FORREST HOUSE

BLOCK 11 SECTION 7 FORREST

DRAWING NO.	TITLE
WA000	PLAN - LOCATION & DRAWING SCHEDULE
WA004	PLAN - DEMOLITION
WA005	PLAN - SITE
WA007	SOFT LANDSCAPE ANALYSIS
WA008	SHADOW DIAGRAMS
WA009	SHADOW DIAGRAMS
WA010	SHADOW DIAGRAMS
WA011	PLAN - AREA GFA
WA011	PLAN - BASEMENT
WA102	PLAN - GROUND FLOOR
WA103	PLAN - FIRST FLOOR
WA104	PLAN - ROOF
WA200	STREETSCAPE ELEVATION
WA201	ELEVATIONS
WA202	ELEVATIONS
WA300	SECTIONS
WA900	STREET PERSPECTIVES

DRAWING TITLE  
**PLAN - AREA GFA**  
SCALE  
**As indicated @ A1**

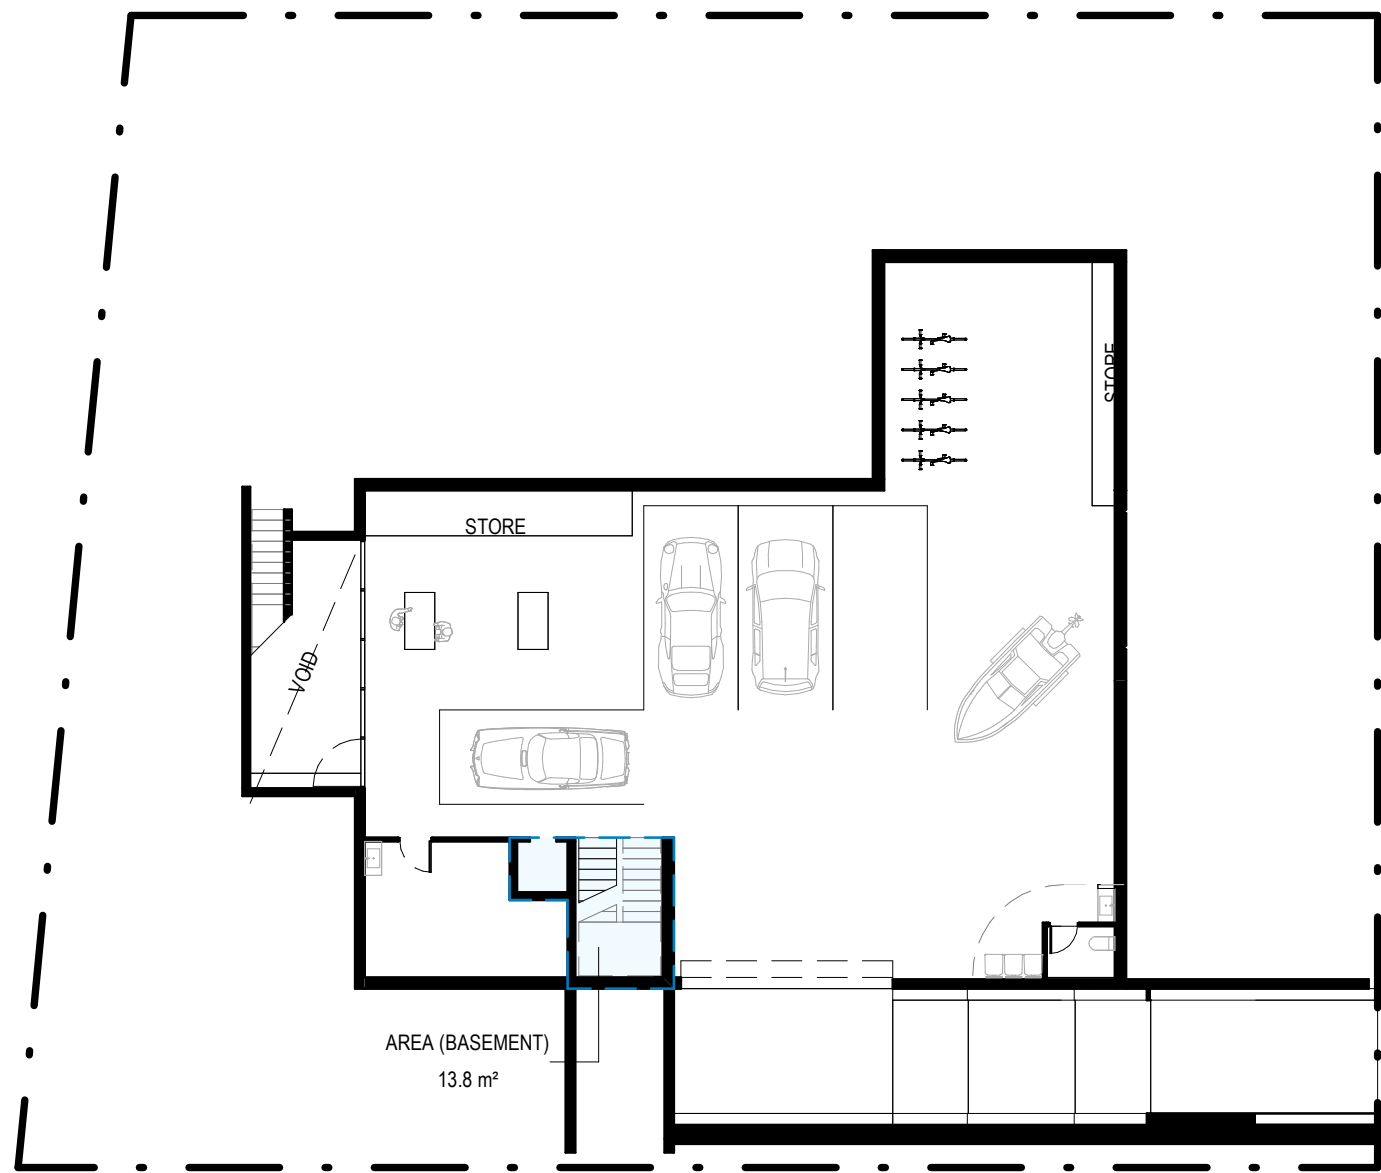
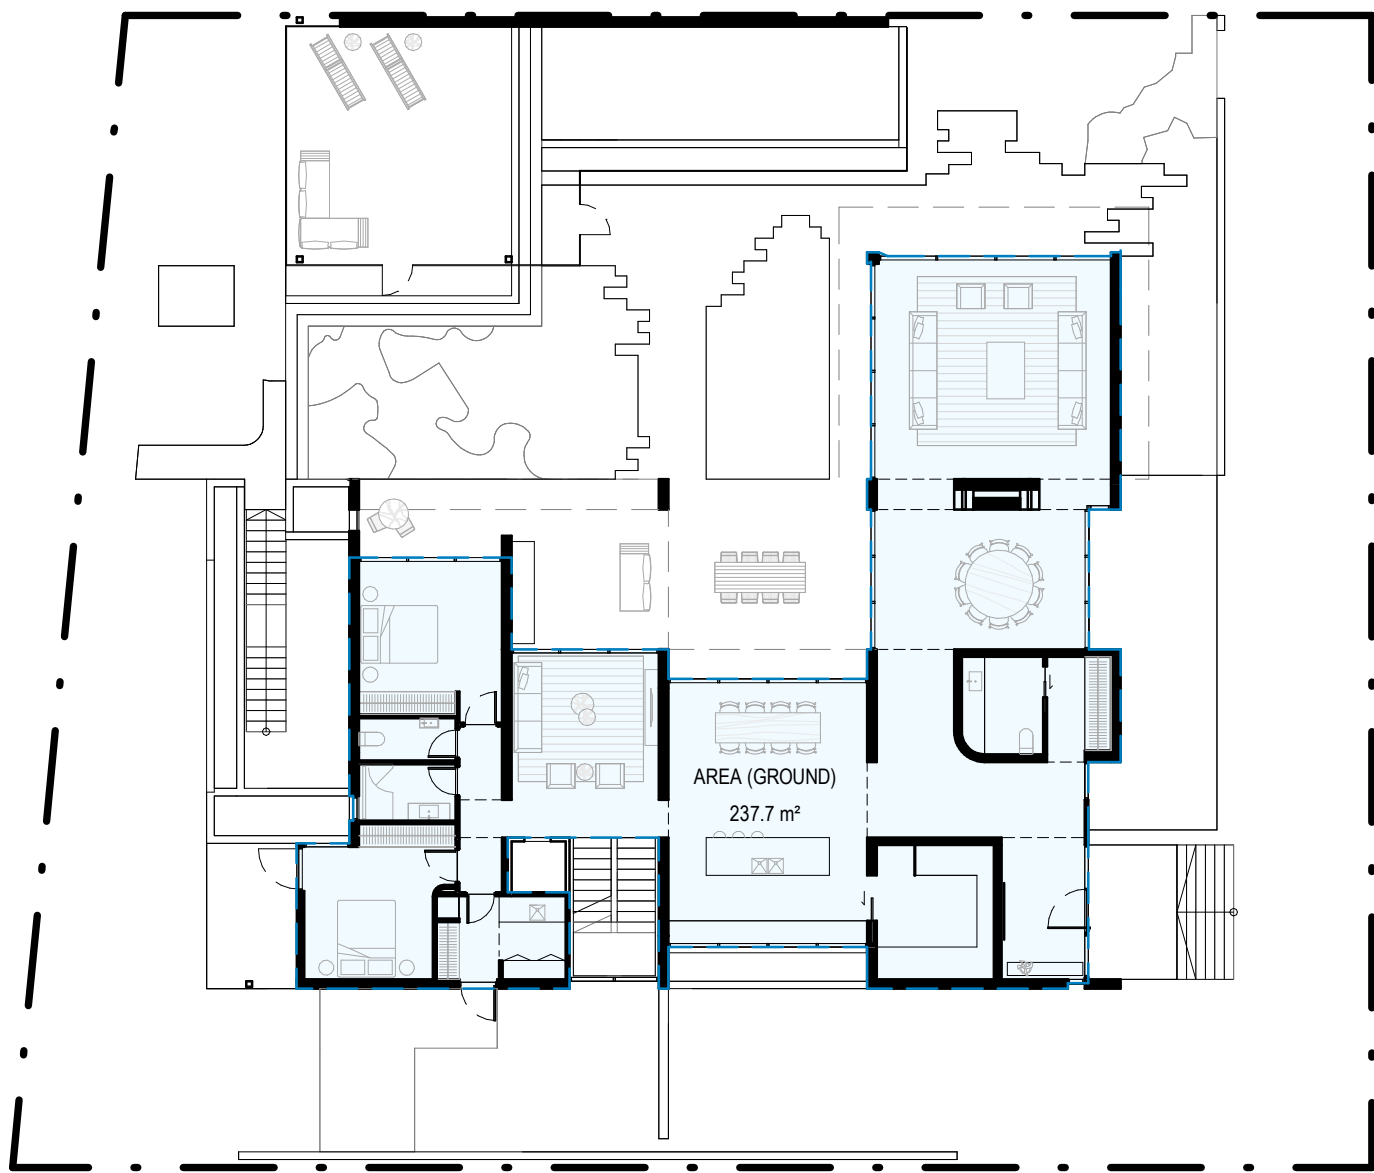
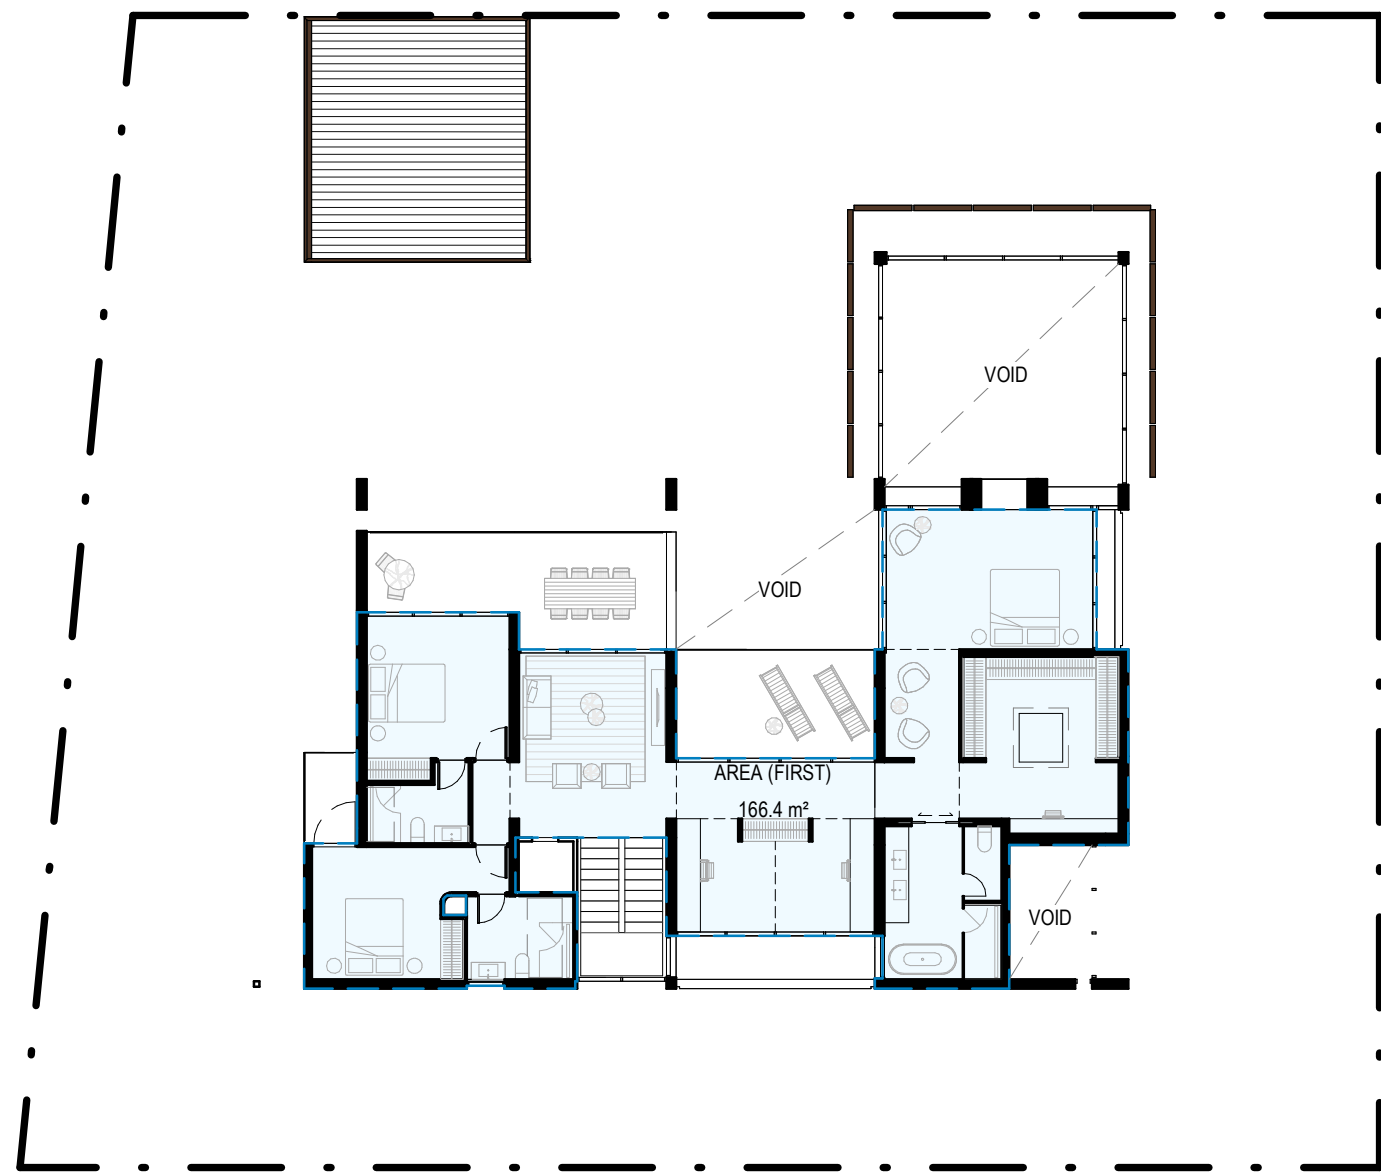
- EASTERN WALLS MOVED 240mm WEST TO SETBACK LINE.
- WESTERN WALLS MOVED 500mm EAST.
- FACADE ARTICULATION WALL REMOVED.
- POOL PAVILION WALLS REMOVED. AREA NOW AN UNENCLOSED COVERED AREA.
- SOFT LANDSCAPING AREA INCREASED, GFA DECREASED.
- SHADOW EXTENT REDUCED AS A RESULT OF THE BUILDING FOOTPRINT DECREASING.
- STUDY AND DINING ROOMS INCREASED IN DEPTH. MASTER BED PLANTER REMOVED.
- SOUTHERN LANDSCAPE ALTERED FOR GREATER VISUAL PRIVACY.
  - FEATURE TREE CENTRED TO MASK VIEWS TO/FROM STAIR
  - ADDITIONAL PLANTING ADDED TO BOUNDARY WALL
  - ADDITIONAL LARGER PLANTING ADDED TO KITCHEN PLANTER (REFER LANDSCAPE DOCUMENTS)

DRAWING TITLE  
**ELEVATIONS**  
SCALE  
**As indicated @ A1**

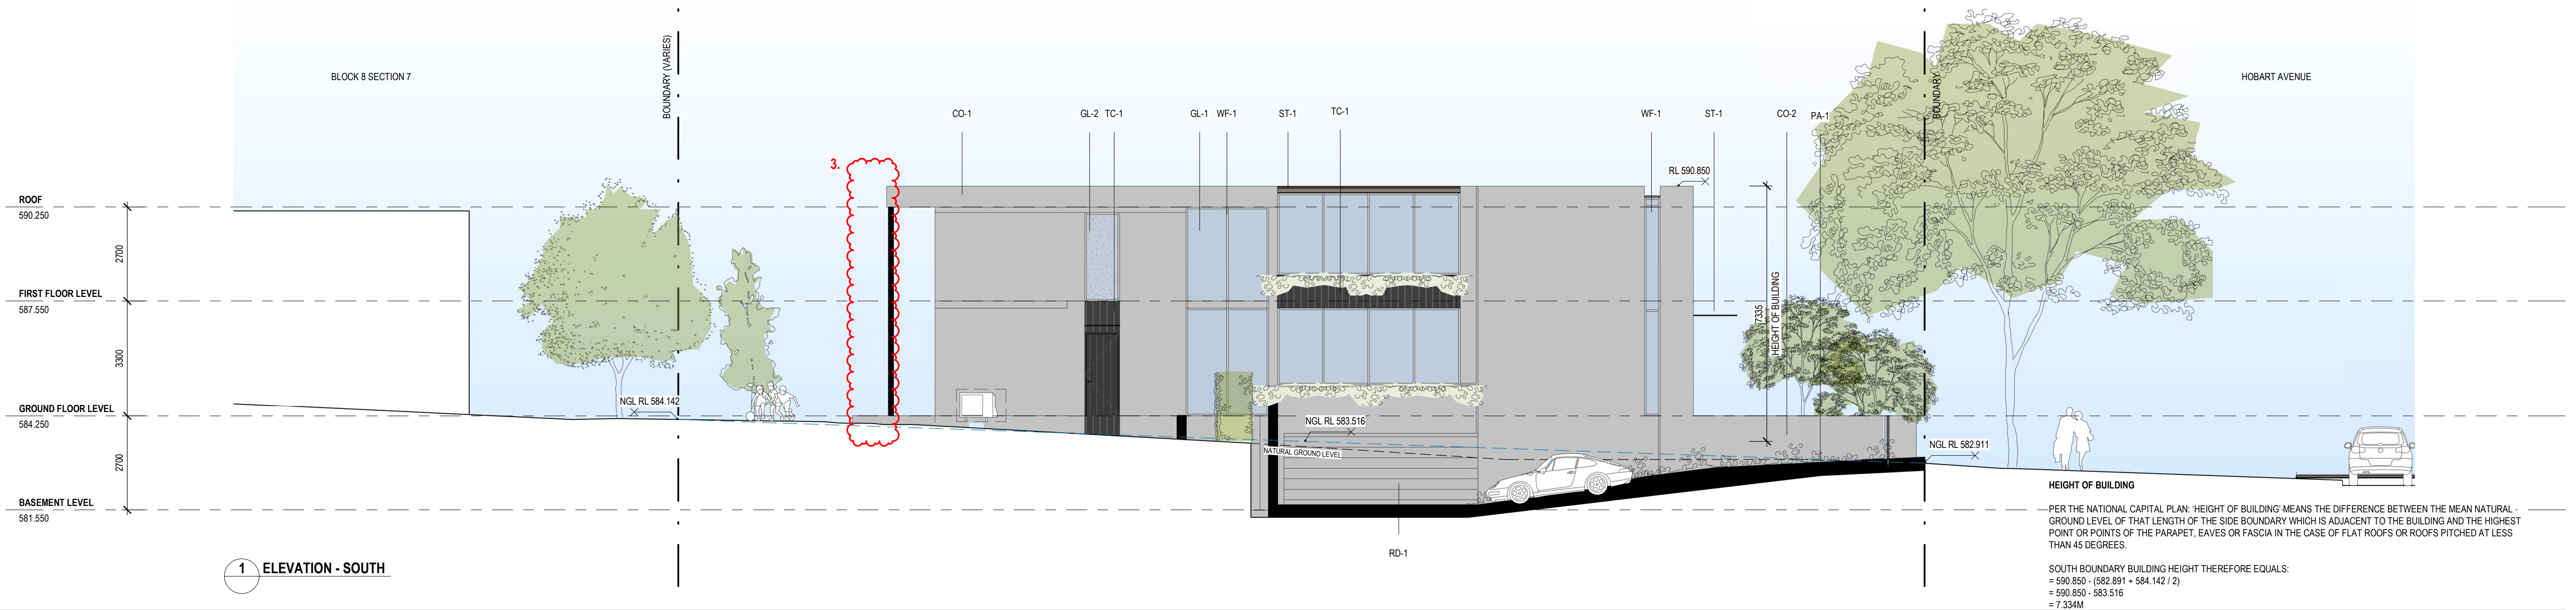
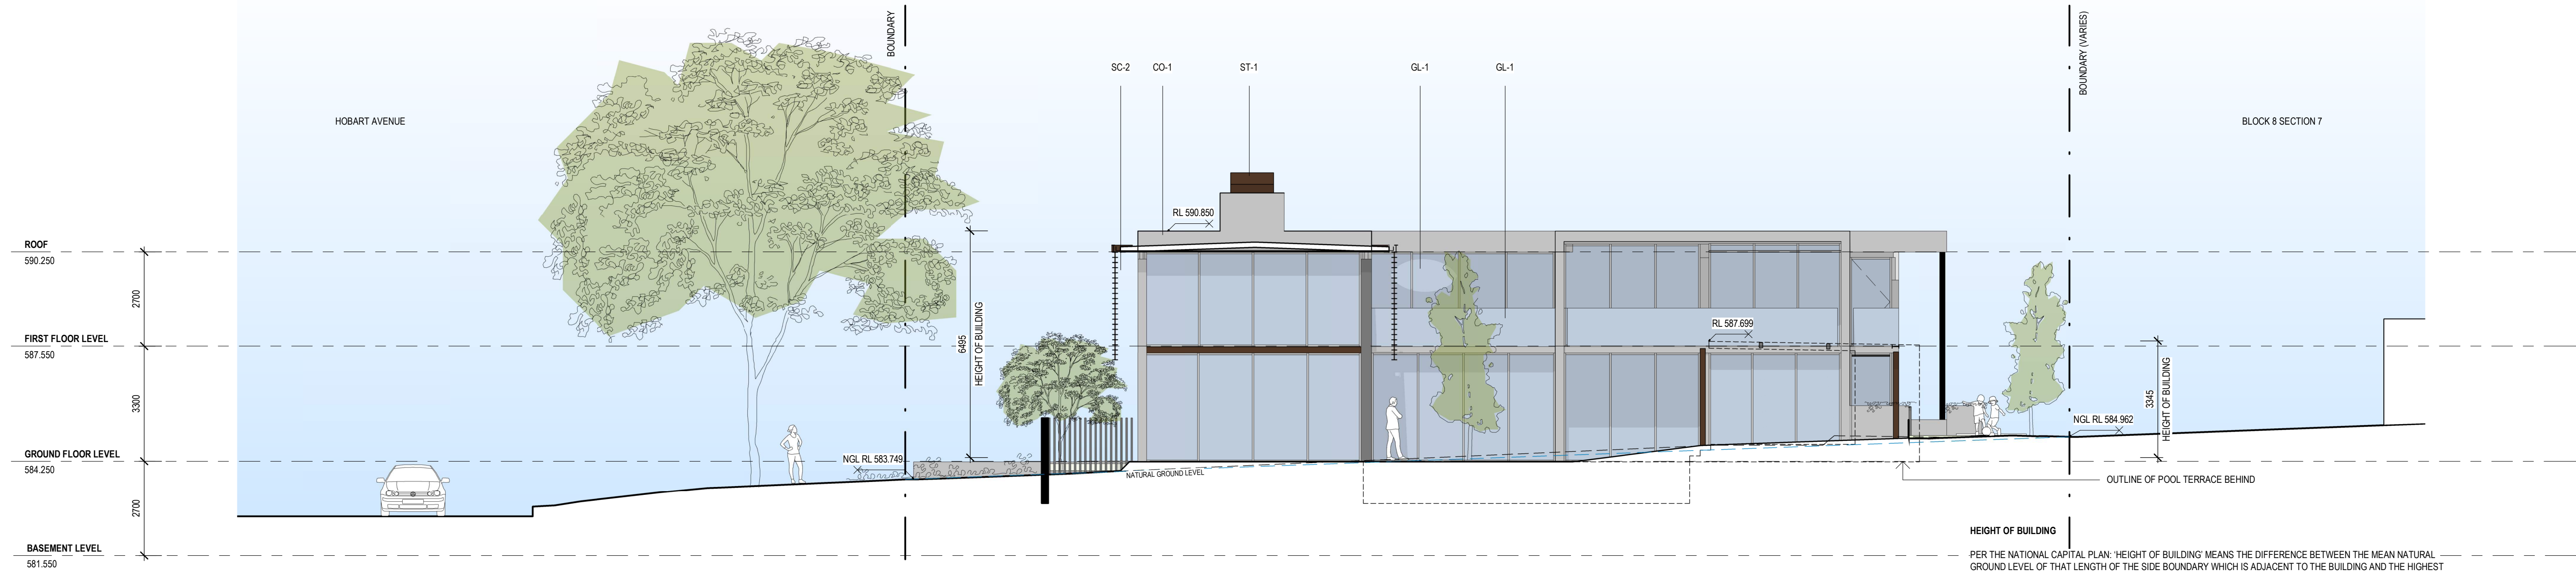
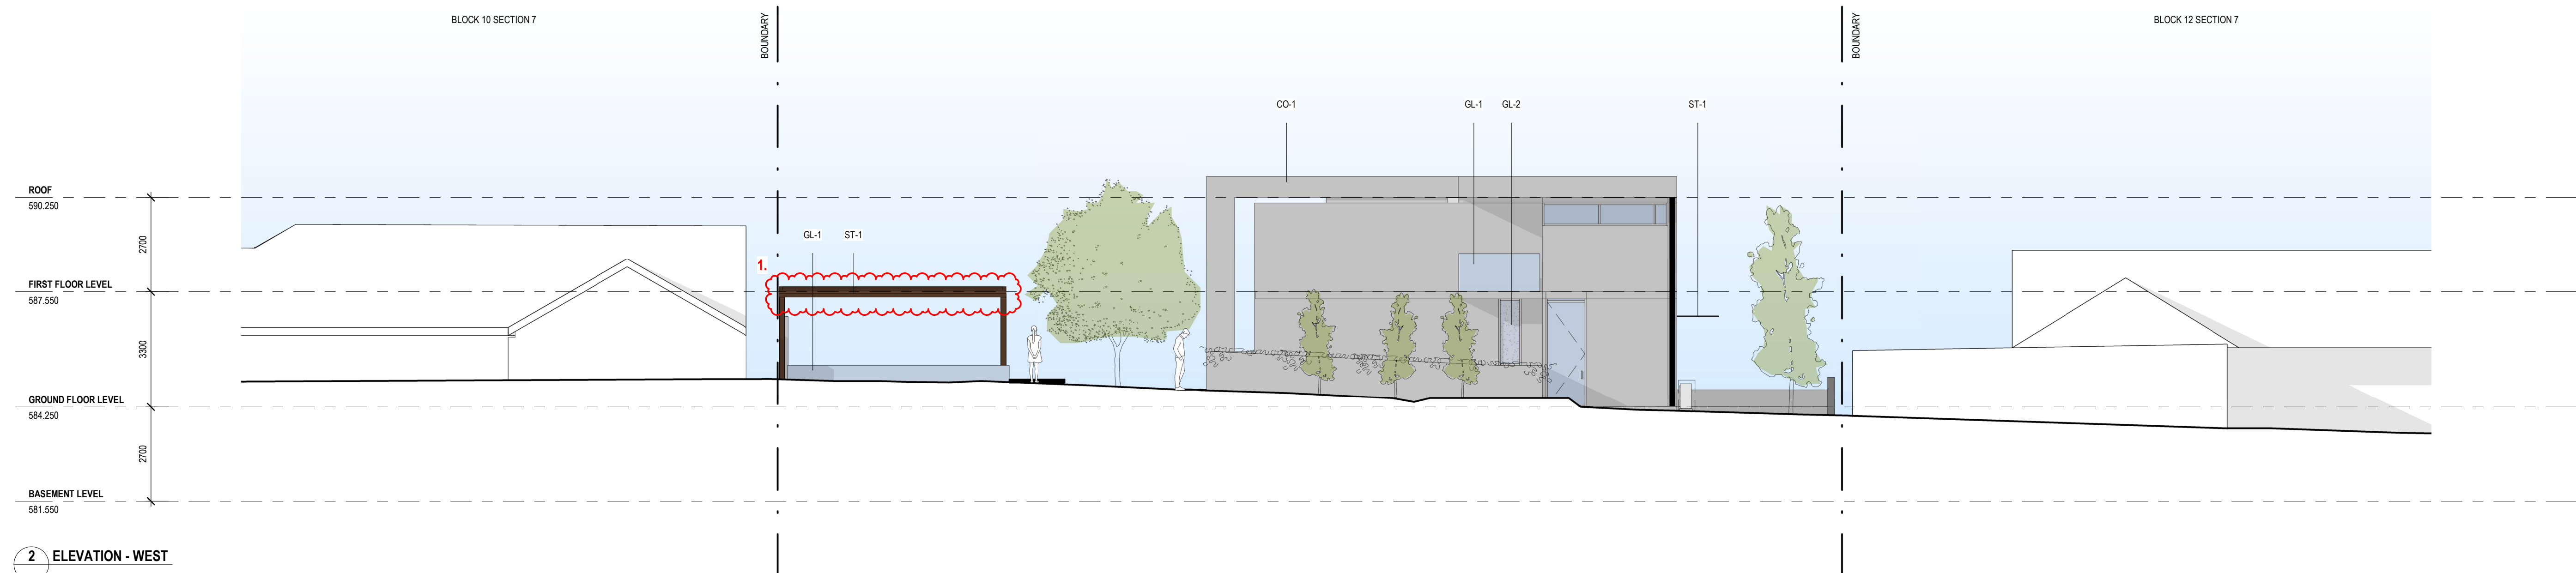
1. ROOF REMOVED FROM POOL HARDSCAPED AREA
